SERVICE BULLETIN

REFERENCE	<u>DRIVELINE/ DIFFERENTIAL</u>
NUMBER	<u>005</u>
DATE	<u>11-30-90</u>
MODEL	<u>RN01, RN02, RN37, VN94, VN01, VN02, VN39</u>

PROPELLER SHAFT HIGH PITCH NOISE

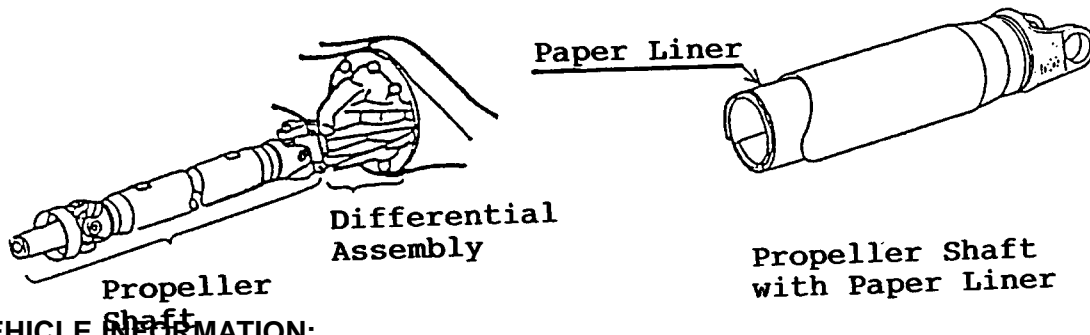
Some vehicles may exhibit a whistle type noise while driving in any of the forward gears at speeds below 50 mph. The propeller shaft has been identified as the probable source of the whistle noise. To diagnose and identify if the propeller shaft is the source of the whistle noise, (for testing) install two rubber exhaust (donuts) hangers (p/n 90301-34207) approximately 18 inches from each end of the shaft. If, after installing the rubber exhaust hangers, the speed range changes or level of the whistle noise is reduced, the propeller shaft is the source of the whistle noise (see illustration below).

Correction: Replace the propeller shaft with the new paper lined propeller shaft (see illustration below). The application chart and part number information is on page 2.
